<p><b>RETURN BIDS TO/RETOURNER LES SOUMISSIONS À:</b></p> <p><b>Bid Receiving - Environment Canada / Réception des soumissions – Environnement Canada</b></p> <p><b>Electronic Copy:</b> <a href="mailto:soumissionsbids@ec.gc.ca">soumissionsbids@ec.gc.ca</a></p> <p><b>BID SOLICITATION AMENDMENT MODIFICATION DE LA DEMANDE DE SOUMISSIONS</b></p> <p>The referenced Bid Solicitation is revised in this document; unless otherwise indicated, all other terms and conditions of the Bid Solicitation remain the same.</p> <p>La demande de soumissions citée en référence est modifiée dans ce document; sauf indication contraire, les modalités de la demande de soumissions demeurent les mêmes.</p>	<p><b>Title – Titre</b> CLEARWATER RIVER NEAR DOVERCOURT – 05DB006 – ALBERTA - PASSENGER-OPERATED CABLEWAY REBUILD</p>	
	<p><b>EC Bid Solicitation No. /SAP No. – N° de la demande de soumissions EC / N° SAP</b> 5000076091</p>	<p><b>Amendment No. - N° de modification</b> 001</p>

## AMENDMENT No. 001

Amendment 001 of Solicitation # **5000076091** is raised to answer questions from Suppliers and to amend the Bid Solicitation closing date.

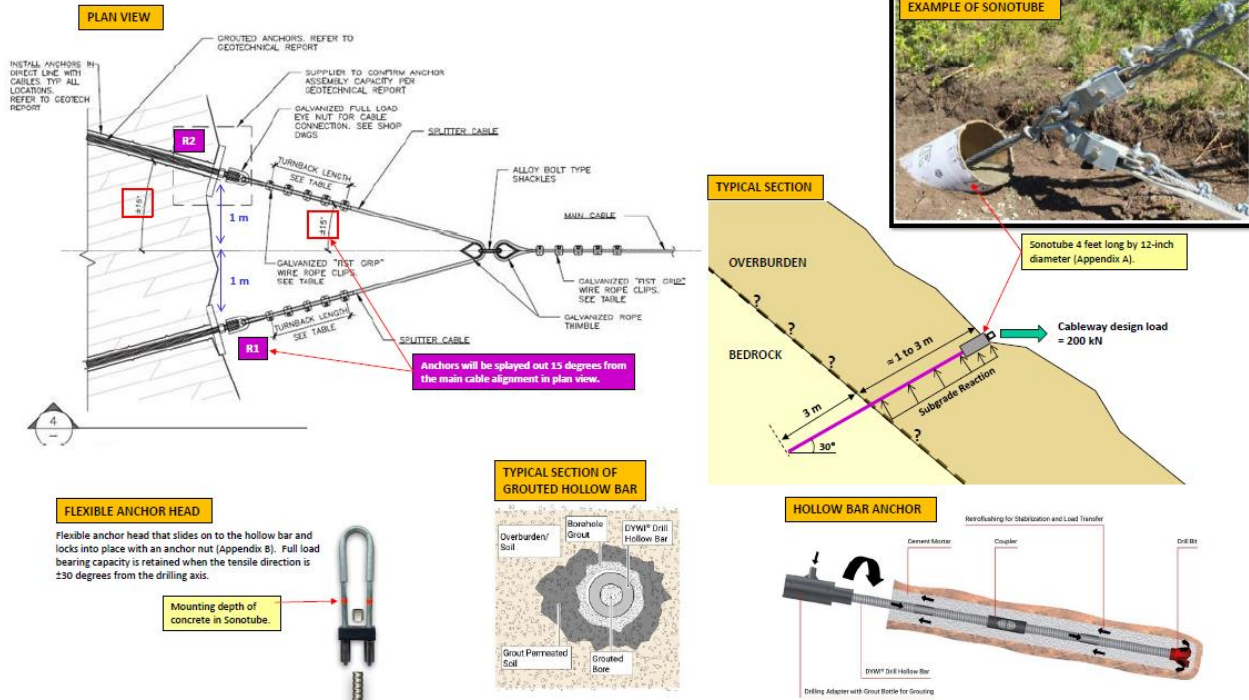
Q4. If there is a rock anchor existing on the left bank, can you please provide its photos or drawings?

A4. The rock anchor installation is not completed yet. Please see the planned design below.
